**75.370**  
**Ventilation Plan**

Mine Safety and Health Administration  
604 Cheat Road  
Morgantown, West Virginia 26508

The request filed November 30, 2005, to maintain three open crosscuts at the Sago Mine, I.D. No. 46-08791, has been reviewed. The response to providing justification of merely increasing the air quantity 4,500 cfm above the minimum requirements is not adequate justification that ensures the safety of the miners. The request may be considered if sufficient justification is presented, other than for convenience, such as specific conditions on the working section that prevent the stoppings from being maintained to and including the third connecting crosscut outby the faces. Therefore, your request is not being approved.

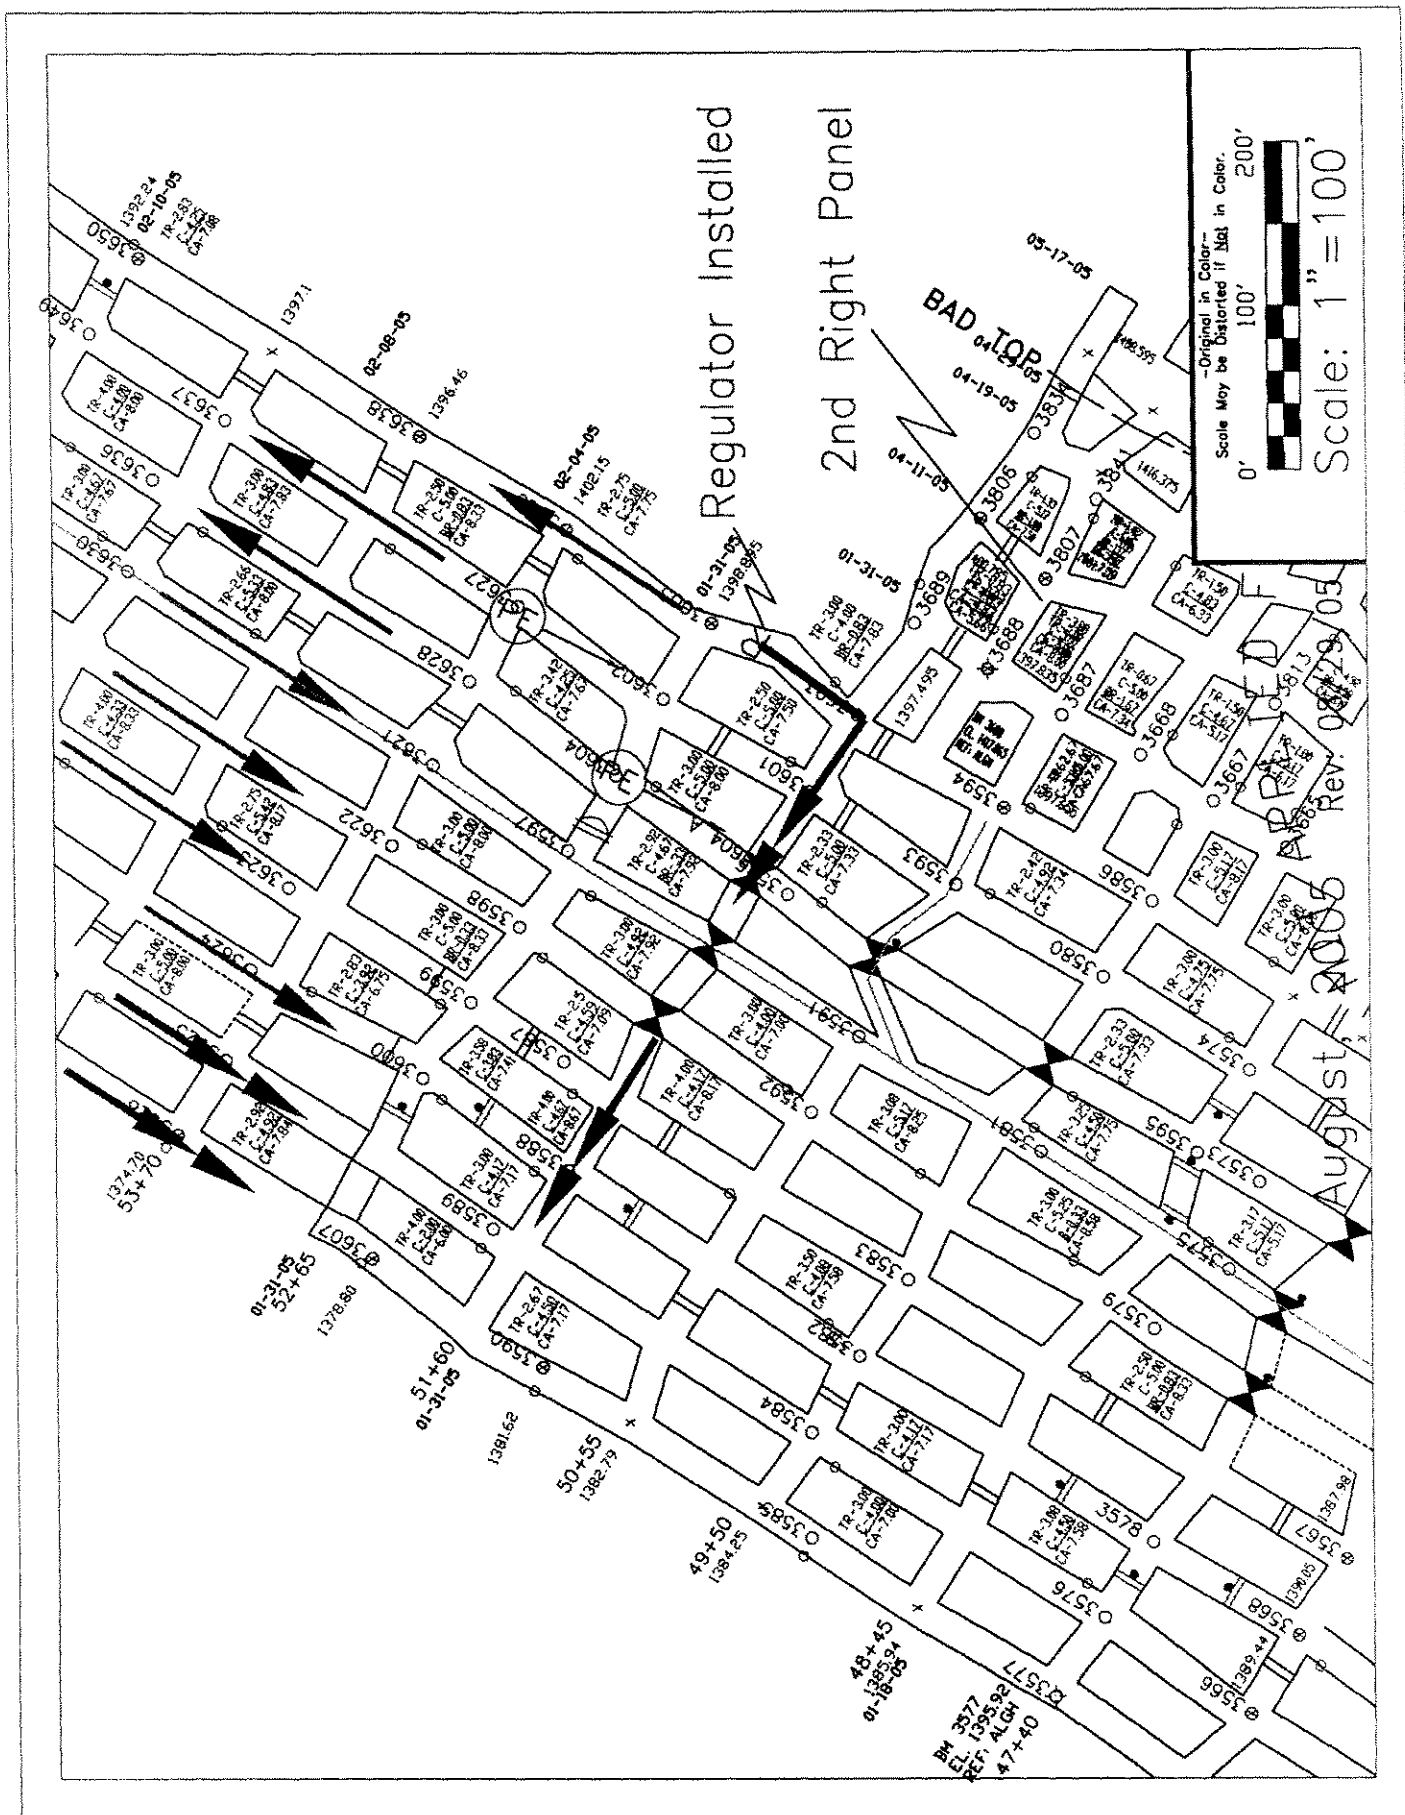
The first change involves a making a major ventilation change relative to the ventilation controls on our North East Mains. This particular change involves changing a current return air course into an intake air course. This will be accomplished by removing several of the former stoppings that were constructed to segregate the former intake and return air courses. Simultaneously with these activities we will also construct a regulator just inby from our 2<sup>nd</sup> Right Mains Area. This regulator is being constructed in order to force virtually all of the intake air inby towards the working units, with a only a small airflow being allowed to flow outby towards the return air flow coming off of the 2<sup>nd</sup> Right Mains Area. We are currently planning to start on this activity once the 2<sup>nd</sup> Left Mains completes their 2<sup>nd</sup> Development Activities, (Bottom Split Mining). (SEE ATTACHED MAP). Note: Due to the fact that there were five (5) neck-ends taken into the rib of the former return entry, which measure greater than 20 feet in depth, we will construct permanent ventilation controls, (stoppings), to divert the air to within 20 feet of these faces. These cuts are depicted on the attached map, (Cut Numbers 3,5,8,9 and 10).

The second change involves the construction of mine seals. The mine seals that are being proposed will be constructed across our North East Mains, just inby the area that will be the future location of the 2<sup>nd</sup> Mains Unit. The proposed seals will be constructed across the North East Mains area in such a manner that the No. 2-8 seals will be constructed first, with seal numbers 1 and 9 be constructed simultaneously. The seals be proposed will be constructed either utilizing our currently approved methodology, (Packsetter Seals), ~~or by the using the attached methodology which we wish to add to our Ventilation Plan, (Omega Concrete Block Seals (See Attached Omega Seal Plan).~~ Removed as per J. Myers 10/6/2005 (EB)

The request filed September 30, 2005, for a ventilation change for North East Mains at the Sago Mine, I.D. No. 46-08791, has been reviewed. The information is adequate and approved. You are reminded that the ventilation change must be conducted in accordance with the provisions of 30 CFR 75.324.

# TEST AREA FOR 2ND LEFT MAINS AREA SAGO MINE

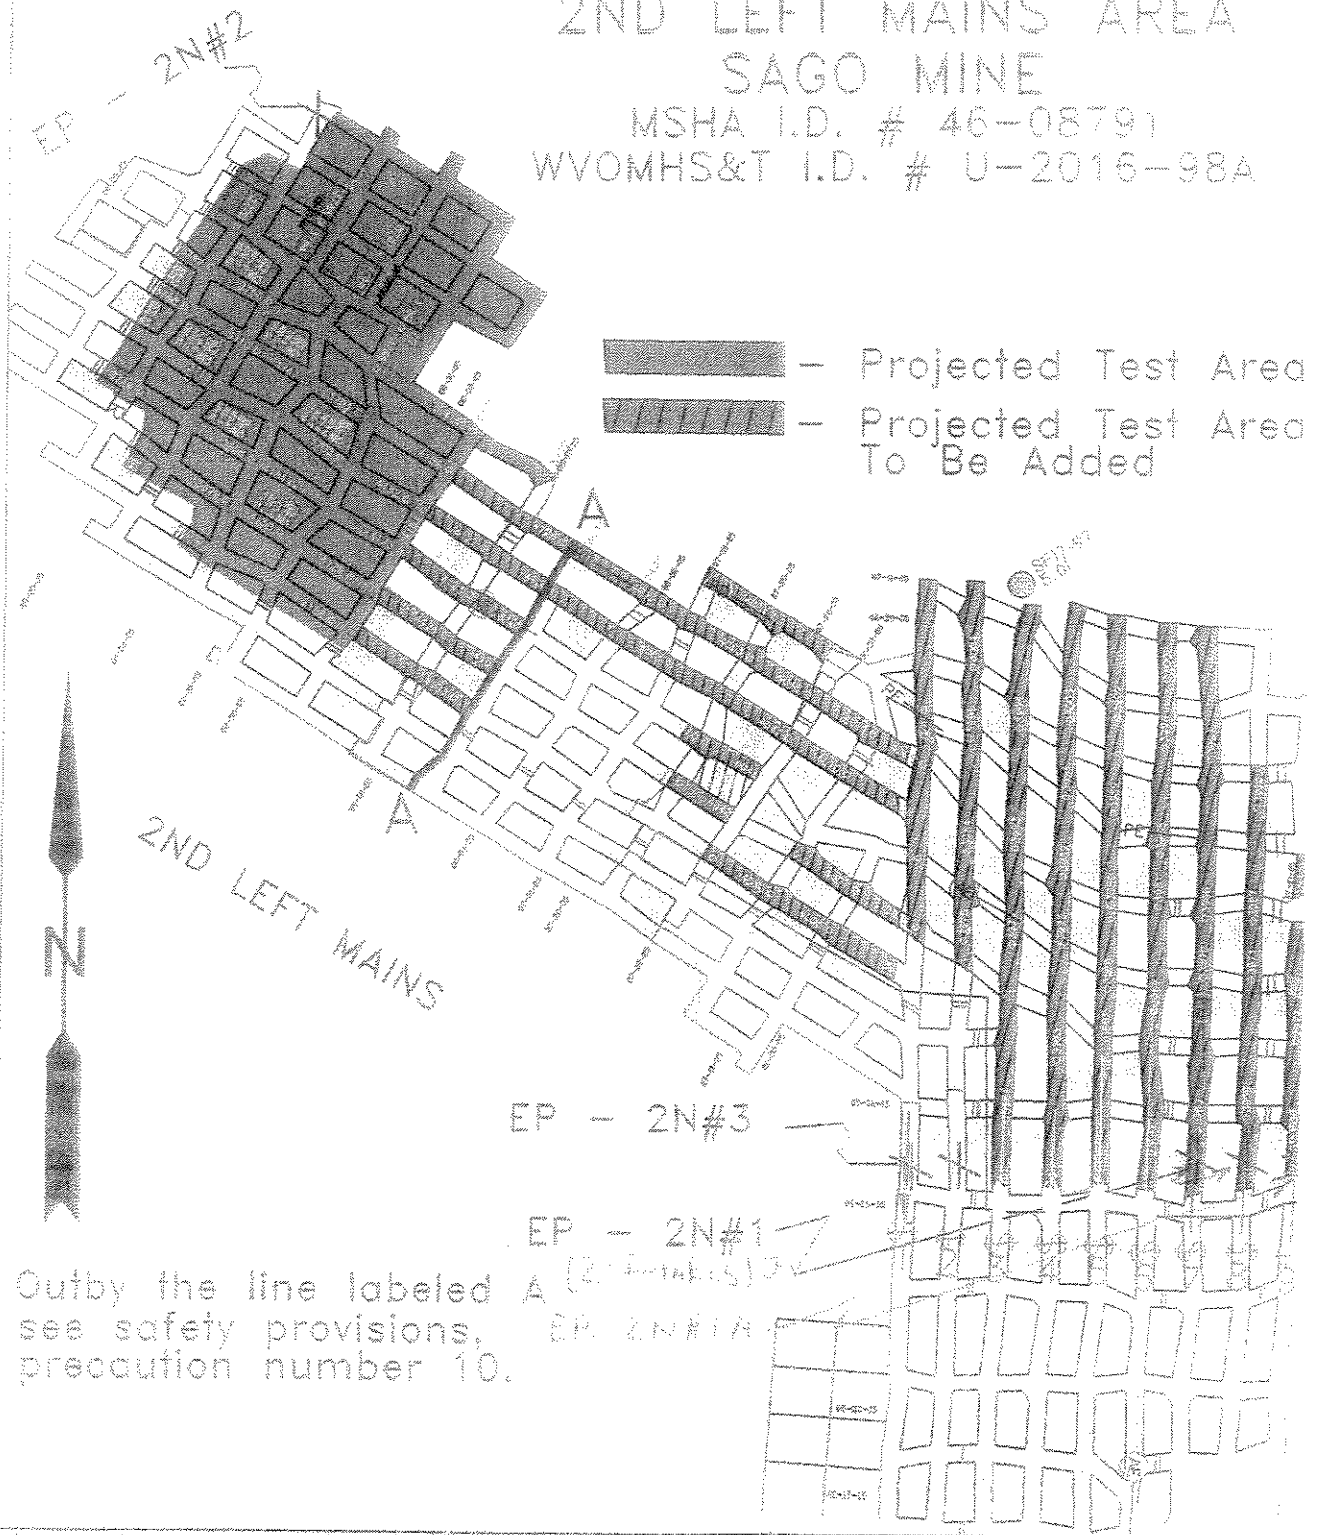
Anker West Virginia Mining Company wishes to amend our September 27, 2005 submittal which allowed our Sago Mine, (MSHA ID # 46-08791), and more specifically our 2<sup>nd</sup> Left Mains unit, to mine the lower bench of the Middle Kittanning Seam. We wish to modify this plan to allow for additional mining in this area. This additional area is shown on the attached map, and displayed and denoted with hatching.

It should be noted that we will comply with all details and information complied in the September 27, 2005 submittal. It should also be noted that we have moved both the intake, as well as the return monitoring points, EP-2N#1 and EP-2N#3 outby so as to cover the additional area we plan to add.

The request filed October 4, 2005, to extend the test area as shown on the accompanying map for the ventilation and evaluation of the worked-out area as a result of additional mining of the lower bench of the Middle Kittanning seam of the 2<sup>nd</sup> Left Mains at the Sago Mine, I.D. No. 46-08791, has been reviewed and is approved. This information will be included in your currently approved mine ventilation plan.

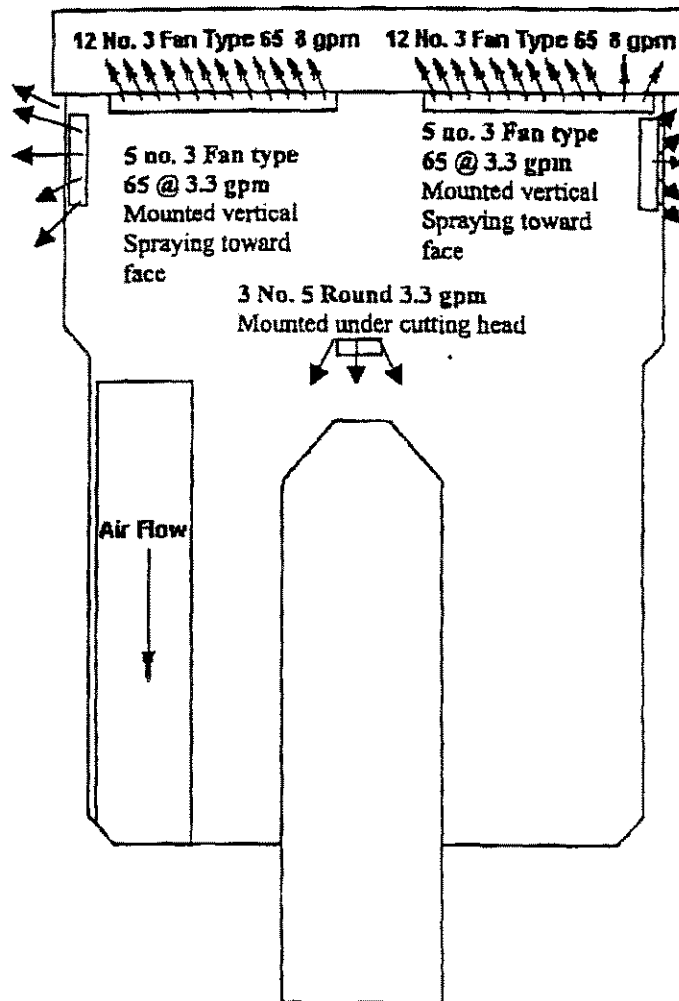
Anker West Virginia Mining Company, Inc. Sago Mine MSHA I.D.  
46-08791 is submitting a ventilation request to change page 5 of the current approved  
Ventilation and Dust Control Plan. The change concerns the number of water sprays on  
the MMU 003-0 continuous miner

The request filed April 18, 2005, to revise page 5, face ventilation parameters for the Eimco 2810-2 continuous-mining machine, MMU 003-0, in the mine ventilation plan for the Sago Mine, I.D. No. 46-08791, has been reviewed. The information is adequate and approved. This information will be included in your currently approved mine ventilation plan.
